DITCH CREEK DAM

WASHINGTON COUNTY, MISSOURI

MO. 30726

PHASE 1 INSPECTION REPORT NATIONAL DAM SAFETY INSPECTION

PLAN OF DAM	
DITCH CREEK DAM	
MO 30726	FIG 3A

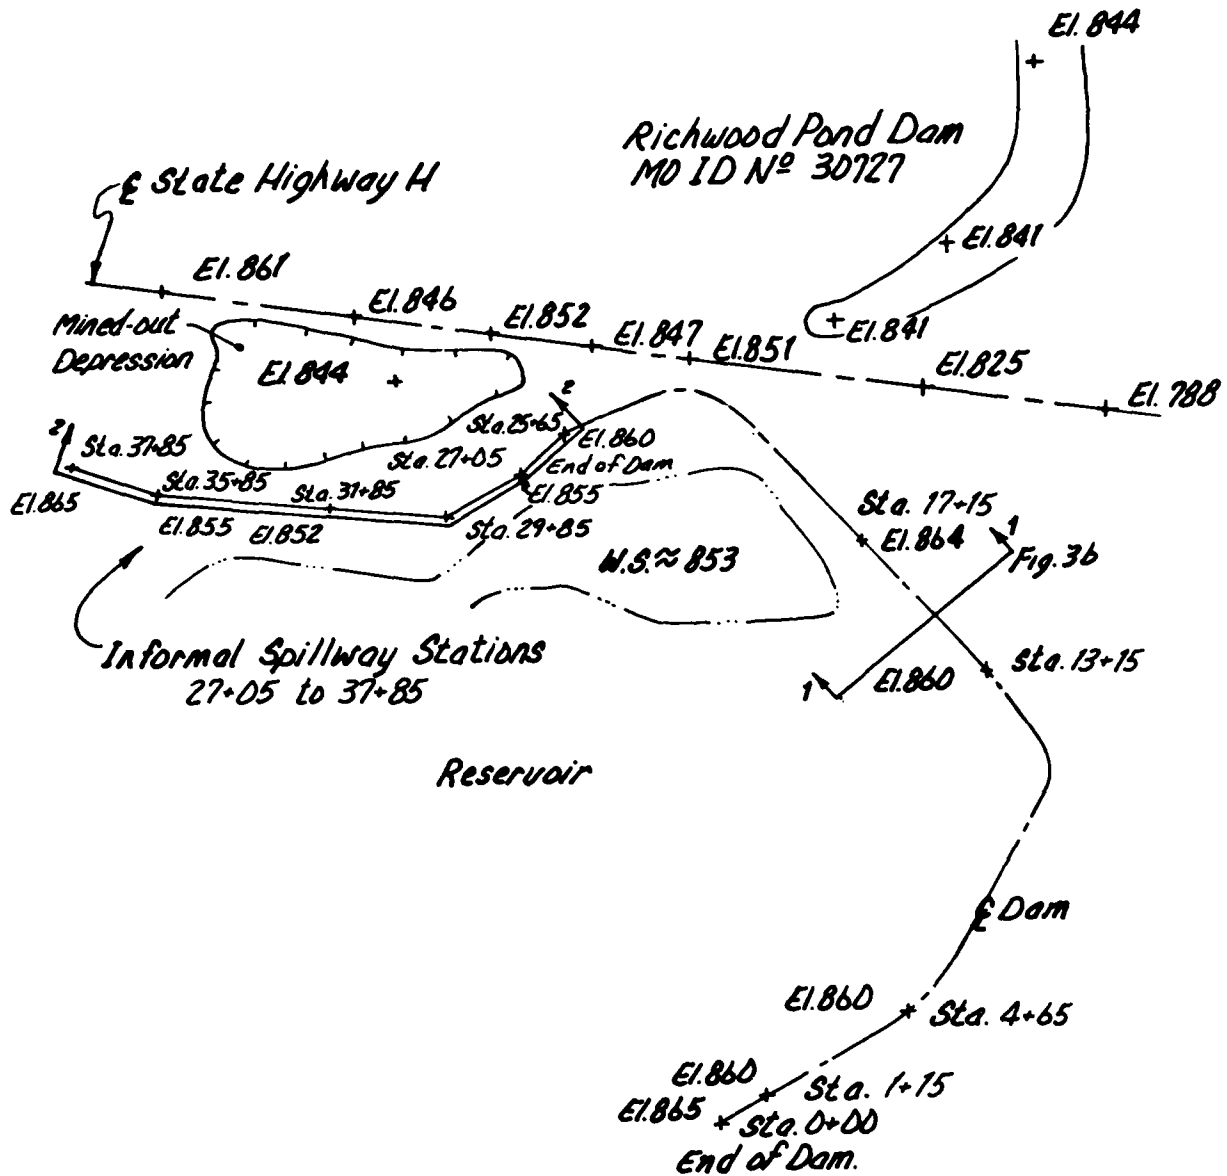
3. Spillway. There is no formal spillway at this facility. The terminology "informal spillway" has been assigned to the low area to the west of the dam (see Figs. 3a and 3b). This overflow area has a moderate to high erosion potential as the stoney clay residual soil is only moderately vegetated. This soil has been observed to be highly erodible when stripped of vegetation and exposed to flow velocities of over 5 ft/sec.

- d. Post construction changes. Following construction of the dam, mining was conducted near the toe of the left abutment. This mining encroached on the dam in several places (Fig. A-1, Appendix A). At one location a 20-ft high 1H to 1V cut face exists immediately adjacent to the toe of the dam. This mining has been discontinued for an estimated two years. The lack of a static or seismic stability analysis precludes an adequate evaluation of the effect of this mining on the stability of the dam.

1. Design and construction of a formal spillway and discharge channel required to pass an appropriate design flood, as an alternate to the present condition where a low area to the west of the left abutment of the dam acts as an informal spillway; consideration should be given to the erodibility of the embankment and spillway.
